Petition Number: 2022-200

From:	Jake Carpenter, PE Review		Travis Miller	
	Jacob.carpenter@charlottenc.gov		Travis.Miller@charlottenc.gov	
	980-221-5675		980-221-5778

Revision Log: Date Description 4-27-23 First Review (TM) 05-24-23 Second Review (TM)

Transportation Summary

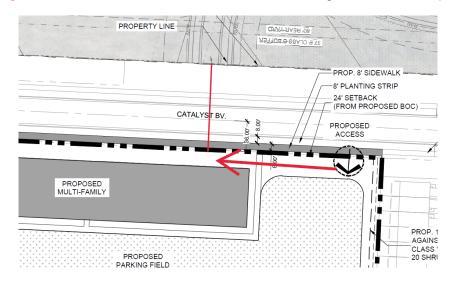
- a. **IBM Drive:** Location of curb and gutter to be moved to 19 feet from roadway centerline to accommodate the Charlotte Streets Map with a roadway typical section of 2+ Avenue with a Shared Use Path.
- b. Catalyst Boulevard: The future location of the curb and gutter is being constructed in accordance with detail U-07, Local Collector typical section from the Charlotte Land Development Standards Manual.

NOTE: Additional distance from center line to back of curb may be required in locations where a median is present or around intersections and interchanges.

Label and dimension the curb and gutter from the centerline for each road on the site plan.
